PD Modification Application: PRS 25-0831

Development Services Department

The applicant is seeking to modify a 49-acre portion of an existing Planned Development, PD 77-0123 as most recently modified by MM 24-0677. The applicant is requesting a modification to reconfigure the general development plan associated with MM 24-0677.

BOCC LUM MEETING DATE: August 12, 2025 Case Reviewer: Sam Ball

2.3 Proposed Site Plan (partial provided below for size and orientation purposes. See Section 8.2 for full site plan)

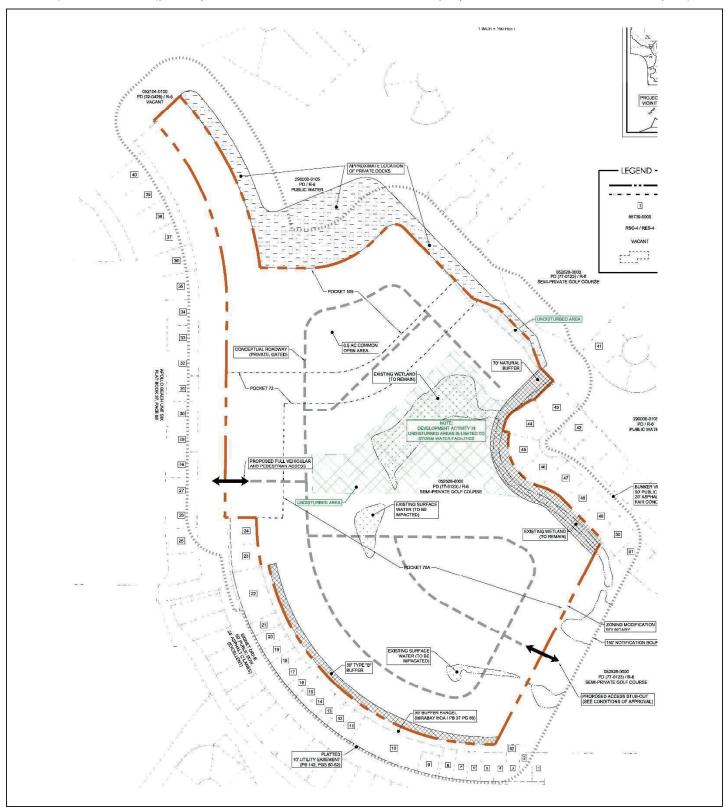
Existing Approvals	Proposed Modifications
Up to 130 single-family, detached dwellings within	Reconfigure undisturbed areas from two smaller areas to one larger area and add an additional undisturbed area in the NE portion of the site.
Pockets 70A, 70B, 72, and 105	Reconfigure internal roadway circulation.
	Identify two existing natural water bodies with wetland impacts due to future development.

The applicant is requesting a minor modification to PD 77-0123, as most recently amended by MM 24-0677, to modify the approved site plan for the development area of a 49-acre portion of folio 52528.0000 to consolidate "undisturbed" open space and wetland areas and proposing to include an additional "undisturbed" area on the northeastern portion of the subject property. While there are minor adjustments to the internal circulation shown on the proposed PD site plan, there are no changes to the uses, intensity or access points.

Prior to site plan certification, applicant shall include the following changes to the general site plan.

Approval of the request, subject to the conditions listed, is based on the revised general site plan submitted October 24, 2024June 18, 2025.
